Access Compliance Report

Public Rights-of-Way

(Curb Ramps)

Intersection ID: 29422	Main Street: BRADSTREET_COMMONS_WY	Cross Street: SHINY_MEADOW_LN	Location: SE
ADA ID: 40700B0F2564	Ramp Type: Perp	Initial Pass/Fail: Fail	Overall Compliance: No
Severity Score: 33.75			
Codes/Mitigation Info/Possible Solution		Field Measurements/Component Compliance

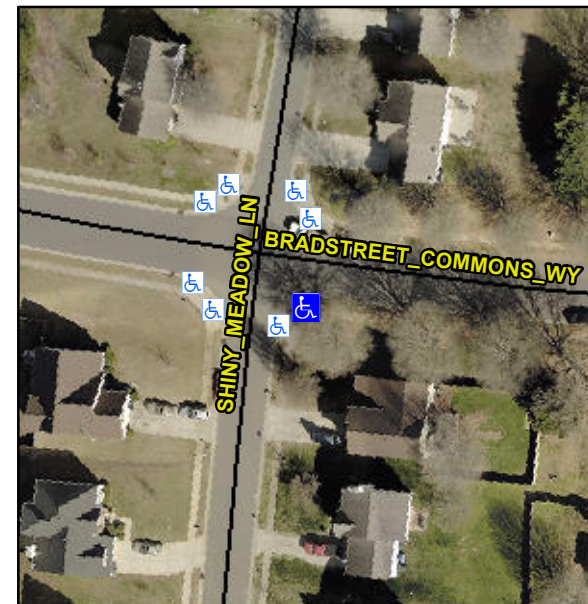
Not Found, R304.5.1, R304.2.2, R304.5.3

Compliance	Description	Data	Compliance	Description	Data
N/A	Ramp Length (in)	48.0	No	Ramp Slope (%)	8.9
No	Ramp Width (in)	47.5	No	Ramp XSlope (%)	5.5
N/A	Flare Type LT	N/A	N/A	Flare Type RT	N/A
N/A	Flare Slope LT (%)	N/A	N/A	Flare Slope RT (%)	N/A
N/A	Flare Traversable LT?	N/A	N/A	Flare Traversable RT?	N/A
N/A	Landing Length (in)	N/A	N/A	DWS Provided?	N/A
N/A	Landing Width (in)	N/A	N/A	DWS Contrast?	N/A
N/A	Landing Slope (%)	N/A	N/A	DWS Length (in)	N/A
N/A	Landing X Slope (%)	N/A	N/A	DWS Full Width?	N/A
N/A	Landing Curb? (Y/N)	N/A	N/A	DWS Offset (in)	N/A
N/A	Shared Landing?	N/A			
N/A	Gutter Ponding?	N/A	N/A	Gutter Slope (%)	N/A
N/A	Gutter Lip Ht (in)	N/A	N/A	Gutter X Slope (%)	N/A
N/A	Painted X Walk1?	No	N/A	Painted X Walk2?	N/A
	X Walk 1 Direction	To N		X Walk 2 Direction	N/A
N/A	X Walk 1 Width (in)	N/A	N/A	X Walk 2 Width (in)	N/A
	X Walk 1 Slope (%)	4.0		X Walk 2 Slope (%)	N/A
	X Walk 1 X Slope (%)	6.7		X Walk 2 X Slope (%)	N/A

Remove & Replace Entire Ramp.
